**RE: Planning and Zoning Decision Appeal for Proposed Warren Park Canoe Launch**

**Re: Responses to Comments for Warren Park Canoe Launch**

**Site Plan Review:** 3206 Warren Park Road  
**Applicant Request:** Canoe Launch  
**Existing Zoning/Use:** Public Buildings District (PUB)

# **Warren Park Canoe Launch**

C002

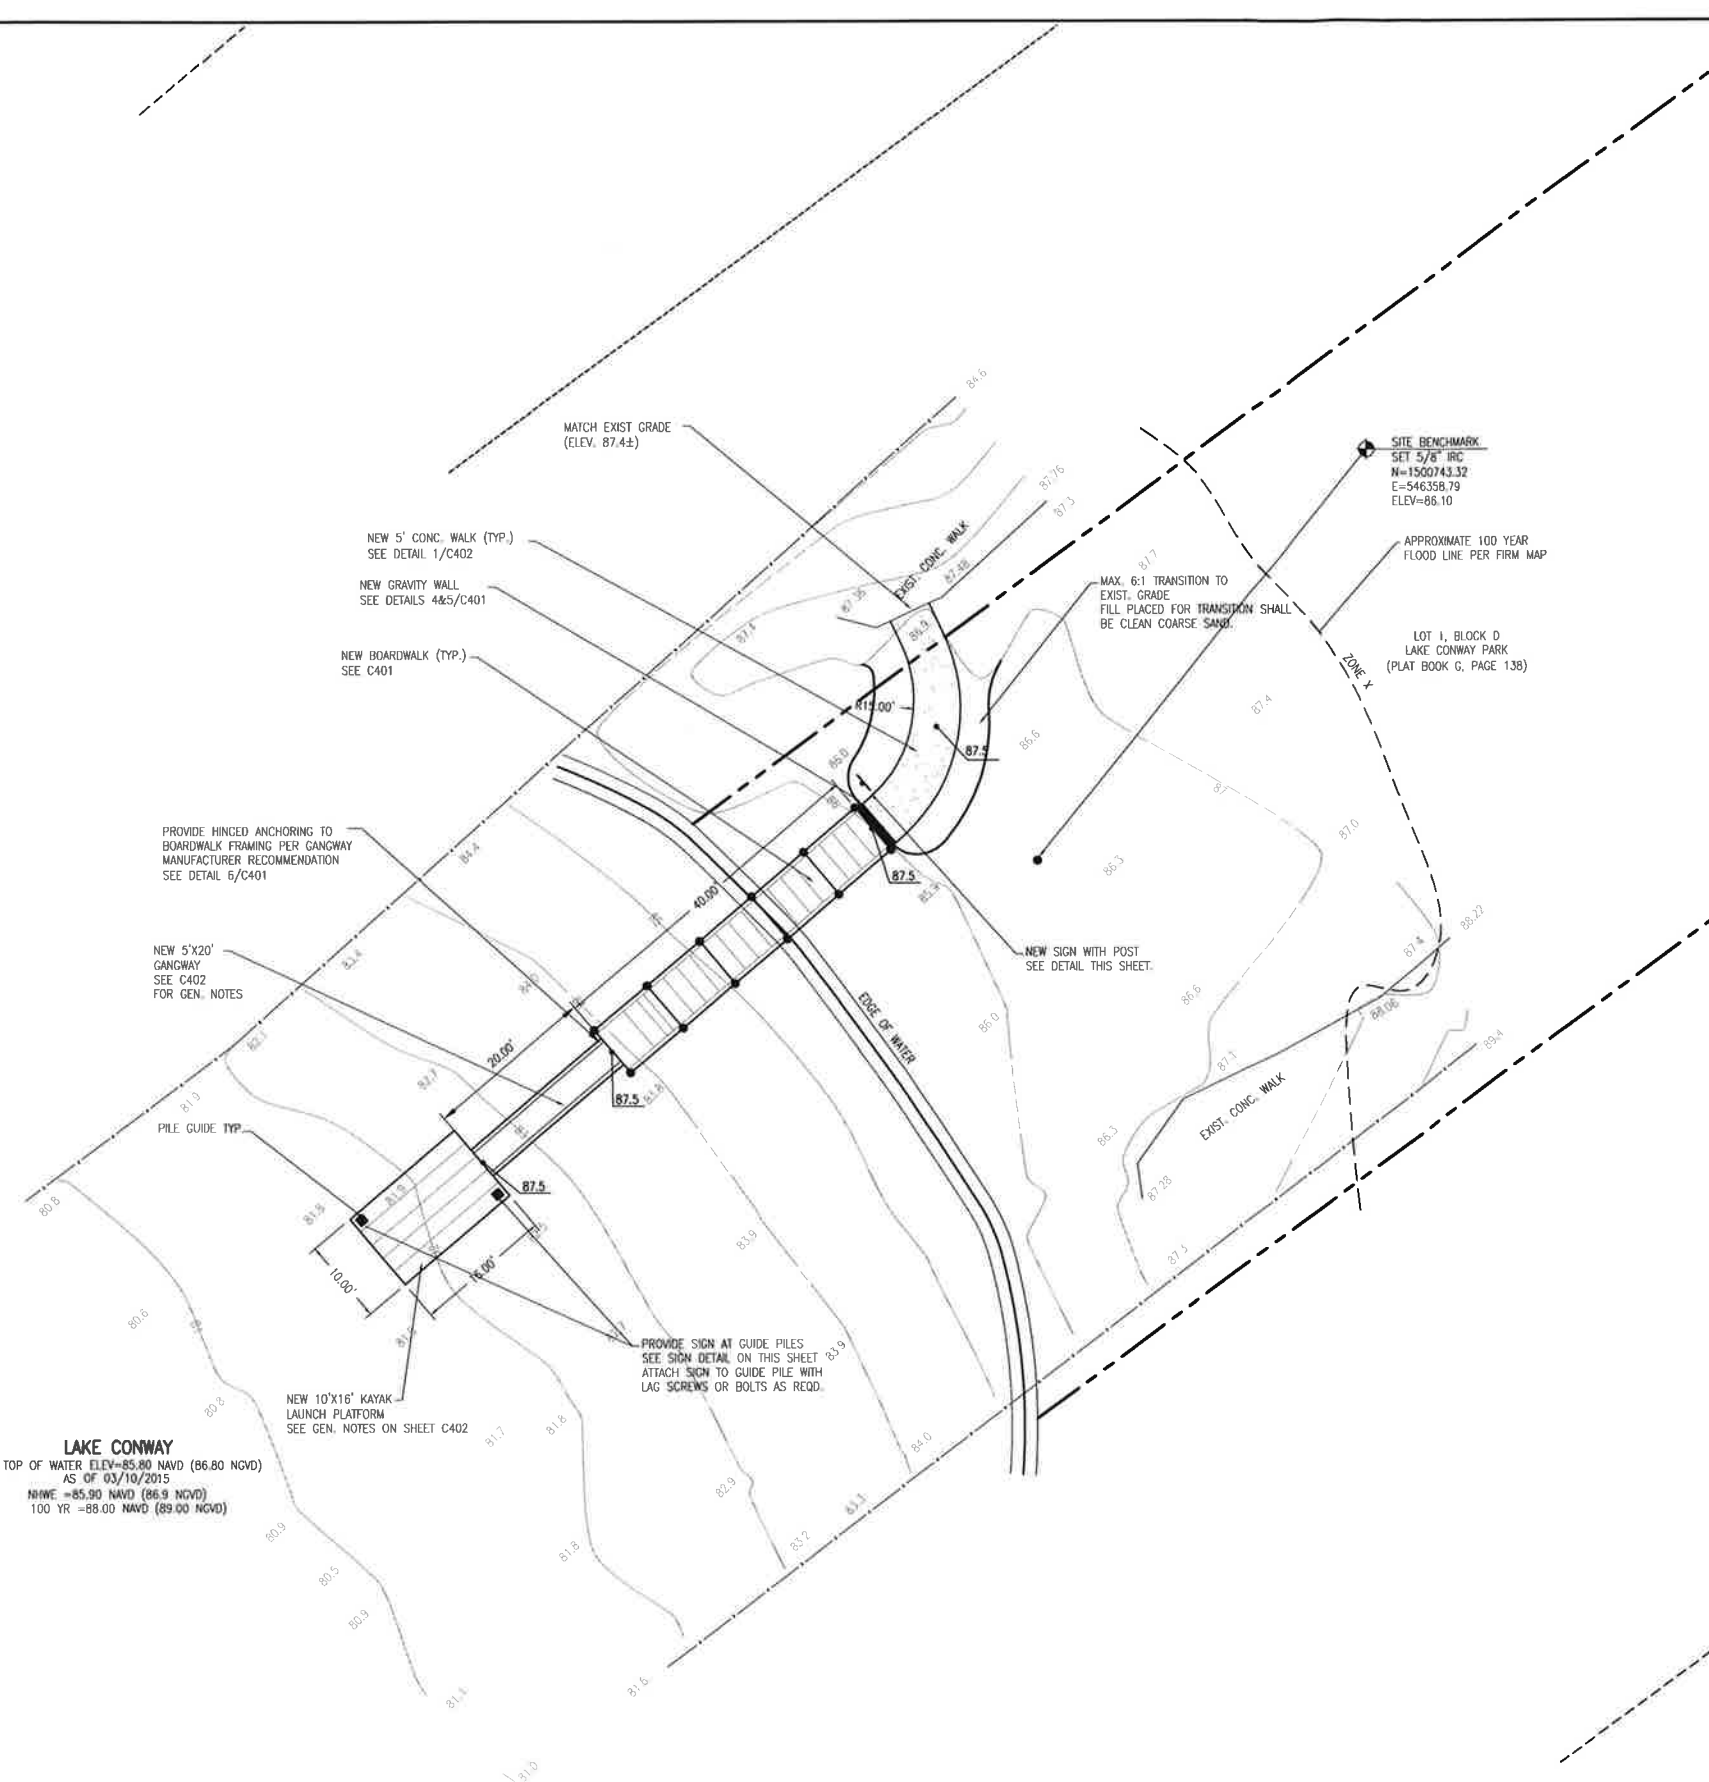
- 6. A correction on Plan Sheet #C002 to indicate the City of Belle Isle zoning district for the parcel as “Public Buildings District” (PUB);

***OCPR Response: We agree with this condition and have made the necessary corrections to the plans.***
